Dover Atwood Corporation (#10626) - COGCC Inspection Photos 1/7/2020

Well: Bear Creek 1-3

API # 009-06598

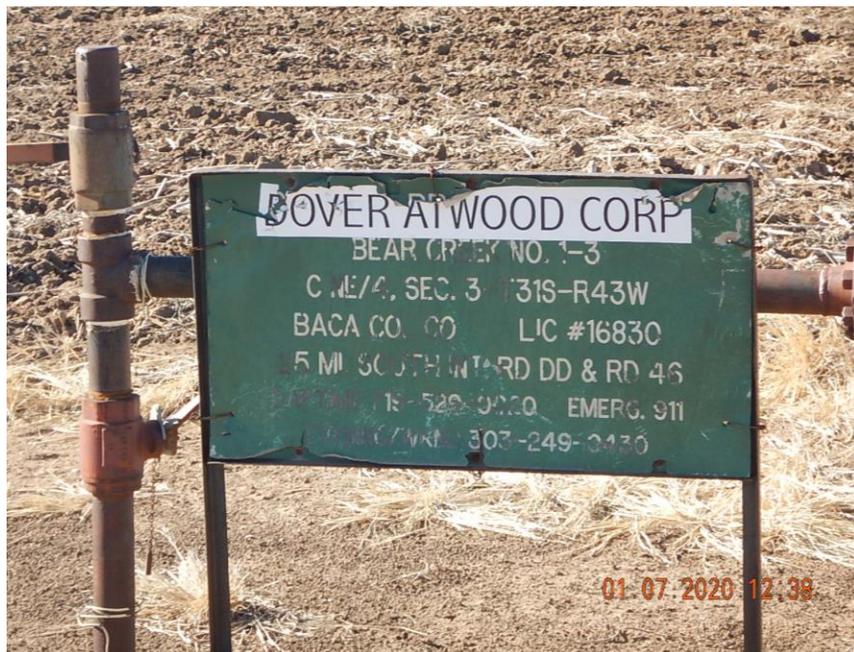
Signage at facility/ battery; Information not fully legible.
